## DOVE CREEK SUBDIVISION

P.O.A.D.P. # 238-B  
 (REVISED)

Re: Dove Creek (Amendment)

MDP# 238-B

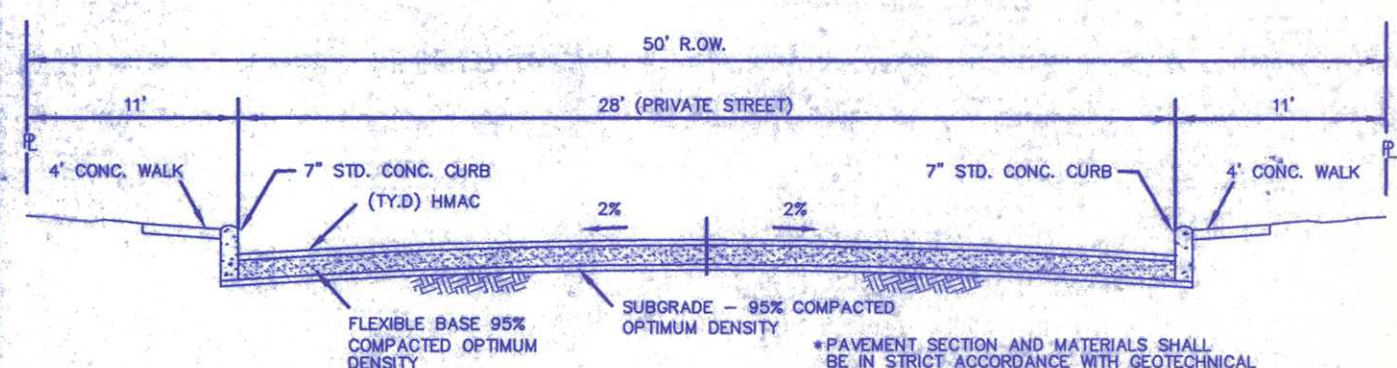
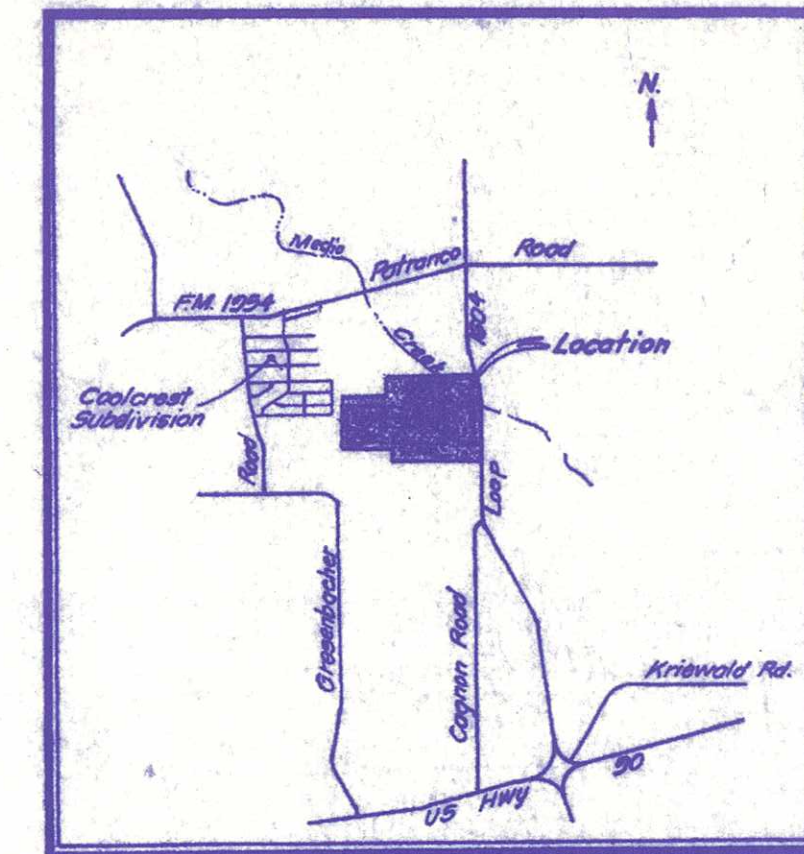
In consideration of public safety and convenience, excessive grades by reason of topography should be avoided in street layouts and arrangements. Any access and R.O.W. issues along state facilities will need to be resolved with the **Texas Department of Transportation (TXDOT)**. For information about these requirements you can contact TXDOT at 615-5814.

**Historic Preservation** states the following: The Texas Sites Atlas indicates that archaeological sites 41BX466, 41BX467, and 41BX1421 have been previously identified within the above referenced property. Also, the property may contain other sites, some of which may be significant. Additionally, the property may contain historical architectural sites. Thus, before any work that might affect any sites is begun, we recommend that qualified professionals conduct an archaeological investigation of the property.

It is understood that this MDP is a conceptual plan and controlled access should be maintained in order to uphold safe and efficient traffic flow. Bexar County reserves the right to address driveways, street design, sight distance, ADA requirements, drainage, and floodplain issues at time of platting.

The property must be platted in accordance to the UDC and the Major Thoroughfare Plan to reflect the approved MDP. It is suggested to work closely with the school district, so they can plan accordingly.
